**BIG HORN COAL COMPANY
10980 SOUTH JORDAN GATEWAY
SOUTH JORDAN, UT 84095**

January 25, 2017

**RE: Objections to Proposed Brook Mine Permit Application, Sheridan County,
Wyoming**

BHCC Objection No. 4 Attachment 1

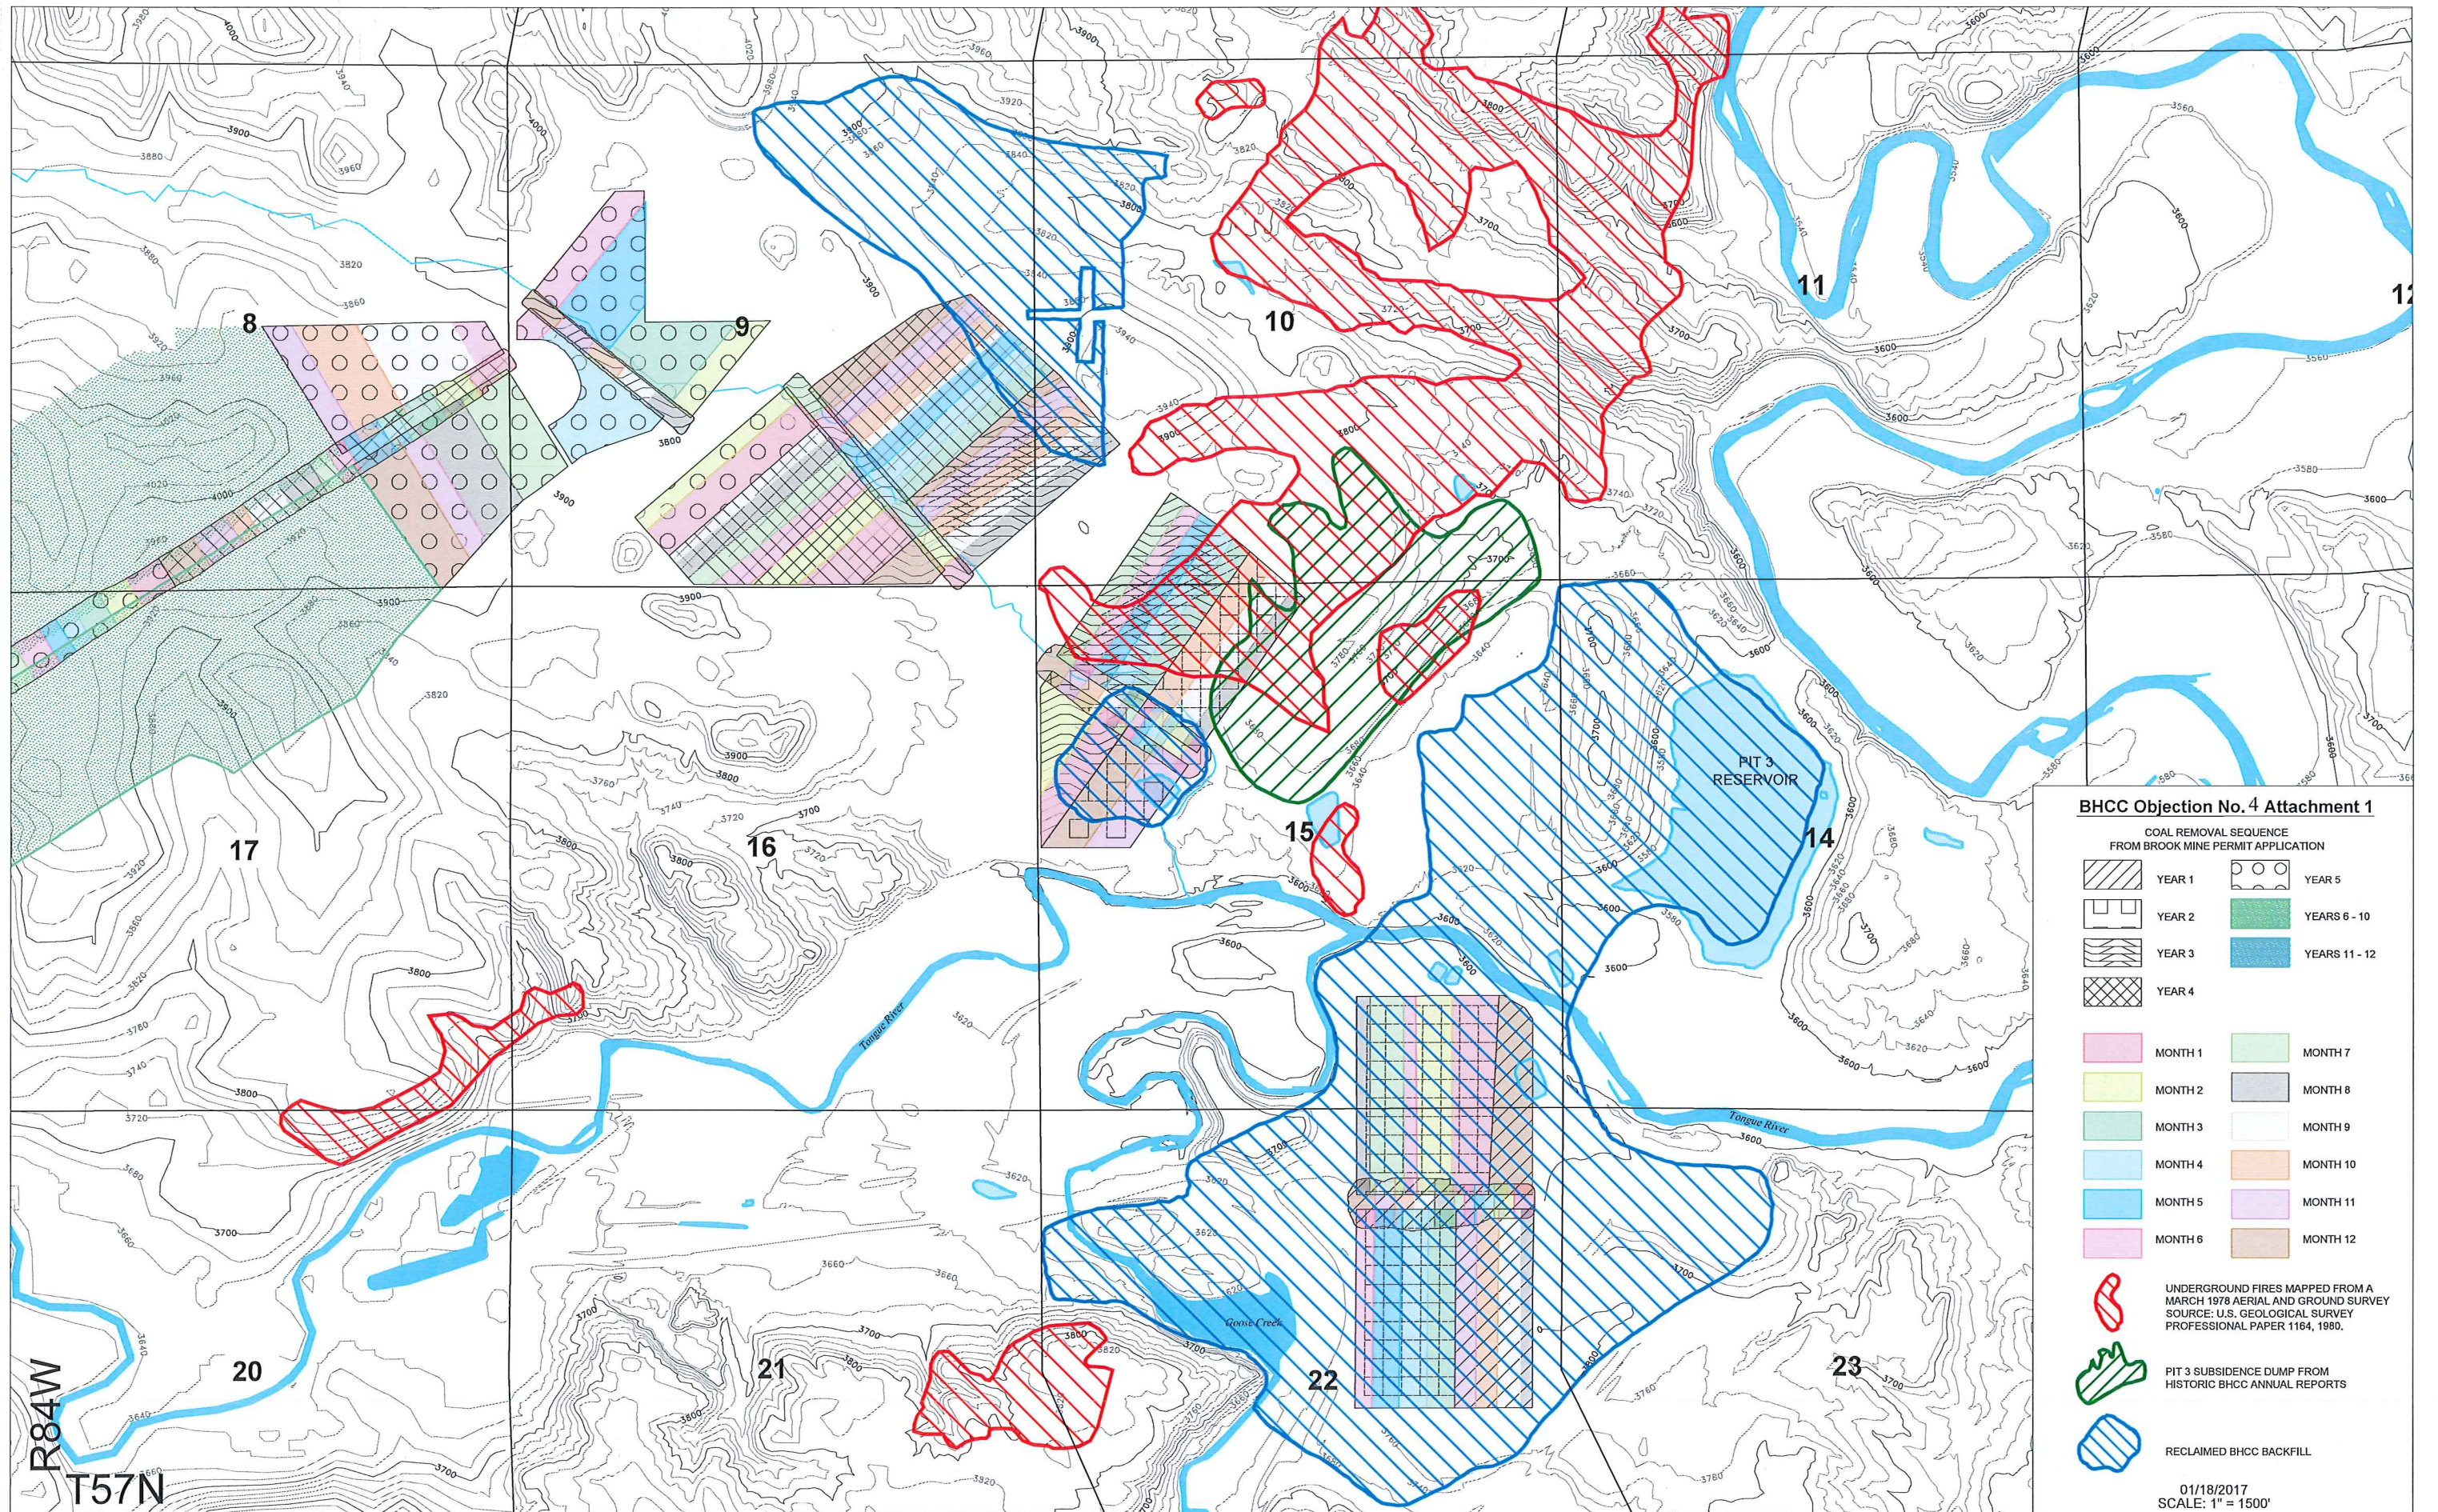
The fire control plan referenced in Section MP.11 and presented in Addendum MP-5 describes measures to be taken to prevent and control fires in the mine pits, fires in the mine's processing and shop facilities, equipment fires and rangeland fires. BHCC objects, however to the Mine Plan and Addendum MP-5 not providing plans to control and extinguish new subsurface coal fires that may develop or existing subsurface coal fires that may become rekindled or enlarged as a result of the highwall mining panels that will be opened outboard of the highwall trench openings.

Attachment 1 provided with this Objection No. 4 is a drawing showing the approximate extent of underground coal mine fires in the area of proposed highwall mining in Sections 10 and 15, T57N, R84W, as reported by the U.S. Geological Survey in 1980. The fires in this particular area originated with mining of the Monarch coal. This and other nearby historic underground mines have long been known to exhibit numerous subsidence features and underground coal mine fires, and in the late 1980s BHCC received approval from the WDEQ/LQD to permanently place nearly 10 million bank cubic yards of overburden over the area shown on Attachment 1 in an attempt to reclaim the subsidence and control the fire. That unique reclamation feature is known as the Pit 3 Subsidence Dump in Big Horn Mine's reclamation history. The proposed highwall mining will develop mine openings in the Carney and Masters coal seams beneath the Monarch seam in areas that are known to still exhibit evidence of underground coal fires. Plumes of steam and smoke have been observed again over the general area of Sections 10 and 15 this winter of 2016-2017. These observations indicate that, in places, the perimeter of the historic subsurface coal seam fires has expanded notable distances from the referenced 1980 boundary delineation.
